TOWN OF DAVIE

TOWN COUNCIL AGENDA REPORT

SUBJECT: Site Plan, SP 4-5-03 Glenn's Automotive Center, 2601 Reese Road, Davie, Florida
Generally located on the southwest corner of Reese Road.

TOWN OF DAVIE
Development Services Department
Planning and Zoning Division Staff
Report and Recommendation

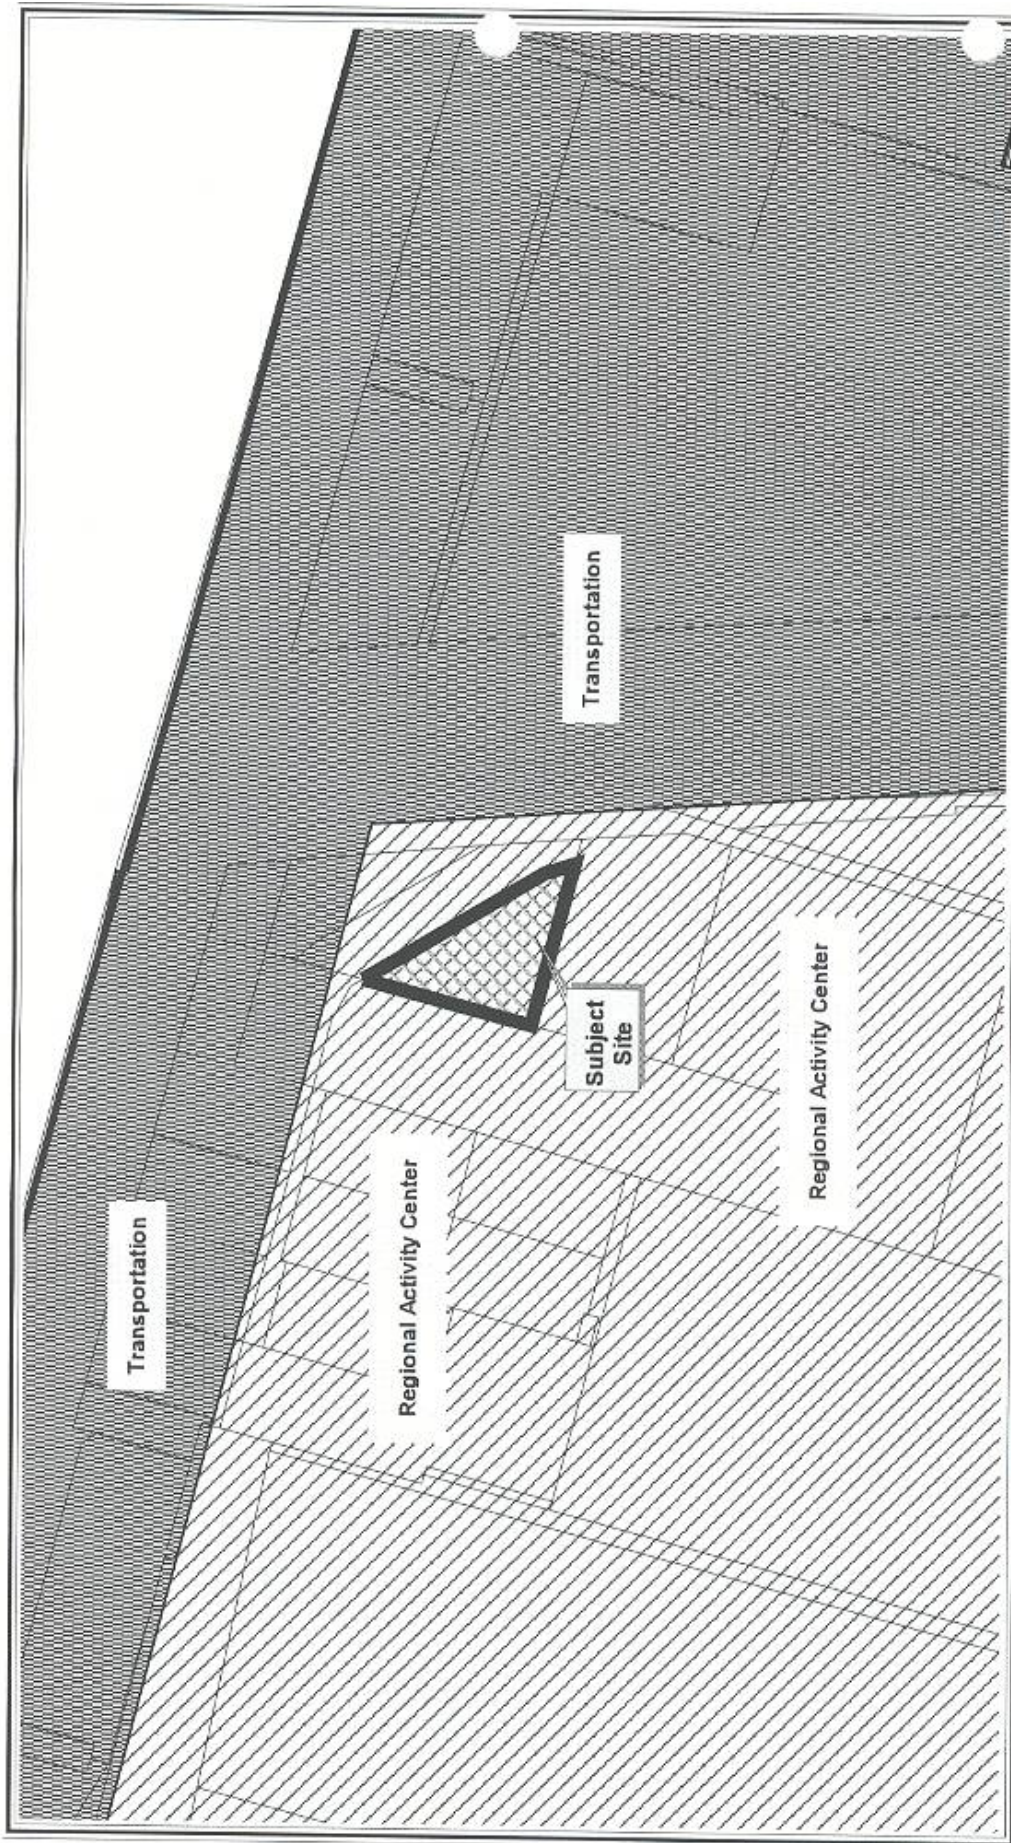
Vice-Chair Evans made a motion, seconded by Mr. Engel, to approve based on the planning report and that canopies be added over the entry doors at the rear of the building to span from roll-up-door to roll-up-door; and to correct the drawing on the plans for the first parking space off the entry driveway. **Motion carried 5-0.**
